Enhancing High-Resolution Forest Stand Mean Height Mapping in China through an Individual Tree-Based Approach with Close-Range LiDAR Data

On behalf of my co-authors, we thank you very much for giving us an opportunity to revise our manuscript, and we also appreciate reviewers very much for their positive and constructive comments and suggestions on our manuscript entitled “Enhancing High-Resolution Forest Stand Mean Height Mapping in China through an Individual Tree-Based Approach with Close-Range LiDAR Data” (Manuscript Number: essd-2024-274).

Figure 1: Workflow adopted for the modeling and mapping forest stand mean heights (h_a and h_w) at 30 m resolution across the China's forest. Publisher's remark: please note that the above figure contains disputed territories.

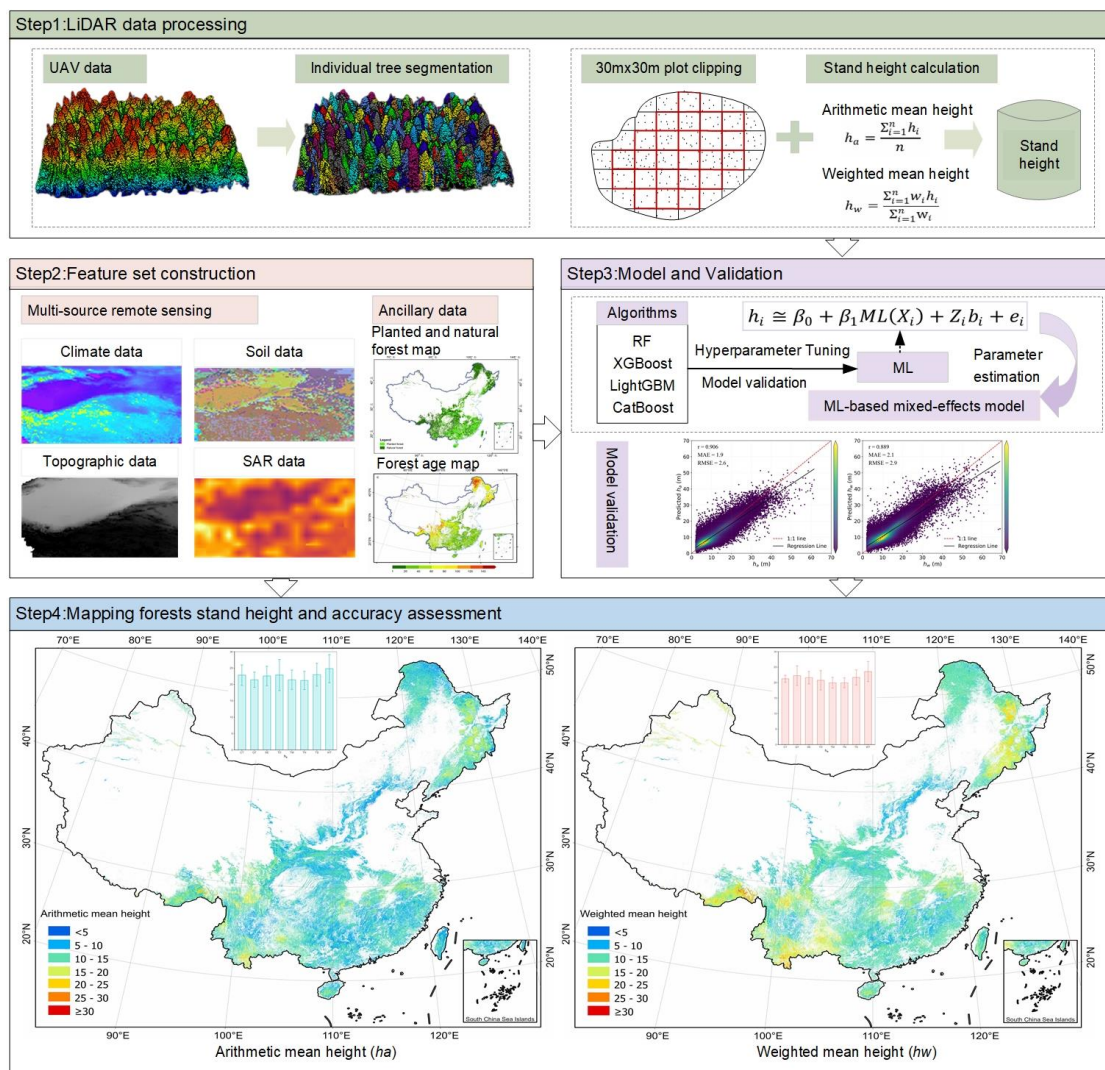
Comment 4: Figure 1 presents the content comprehensively; however, the four images in step 4 are not very clear, making it difficult to see the legend details. I suggest improving their clarity. I also noticed that these four subplots might be the same as the product images and uncertainty analysis figures shown later. Adjustments could be made accordingly.

Reply 4: We thank the reviewer for pointing out this issue. The legend and uncertainty analysis figures in Figure 1 have been adjusted.

Figure S2: Field samples collected for weighted mean height calculation and product validation.

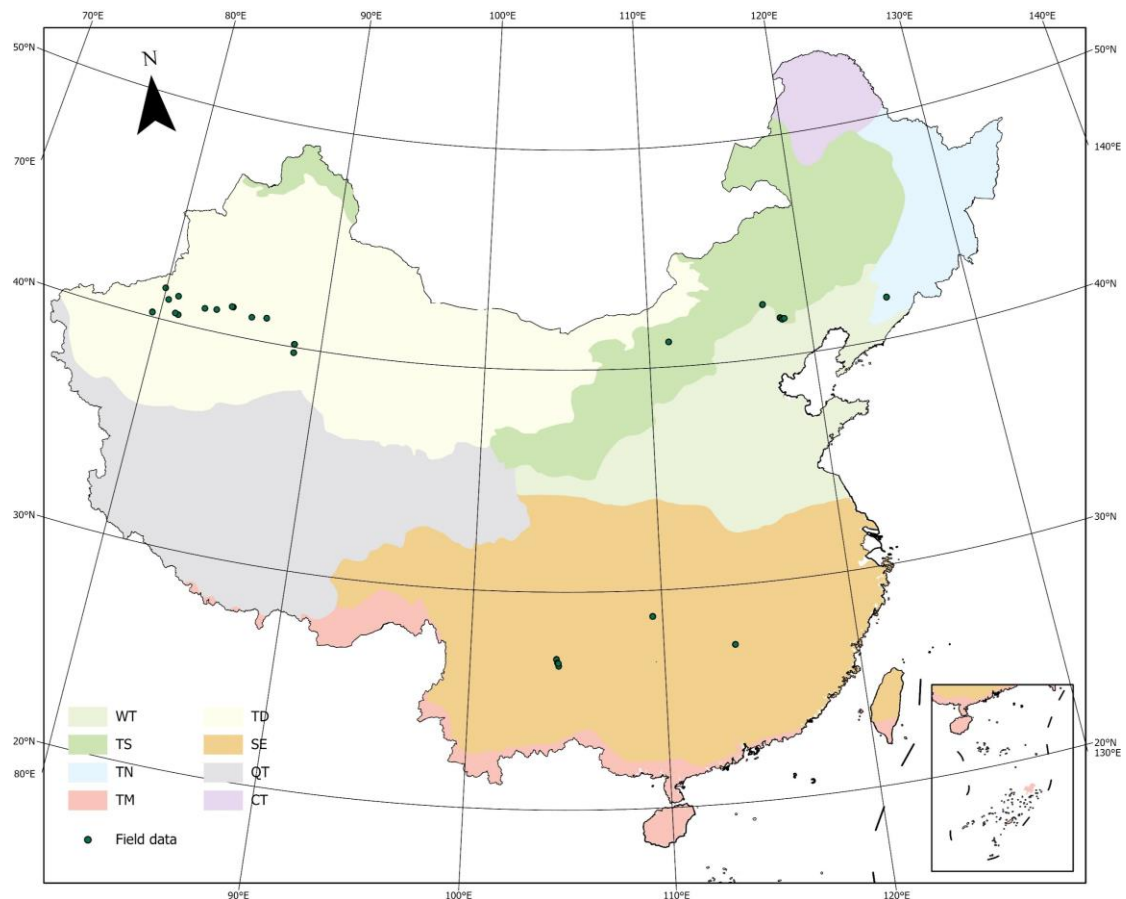
Comment 7: A figure should be added to Section 2.2 to visually present the field data distribution?

Reply 7: Thank you for the reviewer's reminder. Considering that field data and lidar data display more clearly, we have added the field data distribution in Supplementary Figure S1. Please refer to supplementary Figure S1 for details.
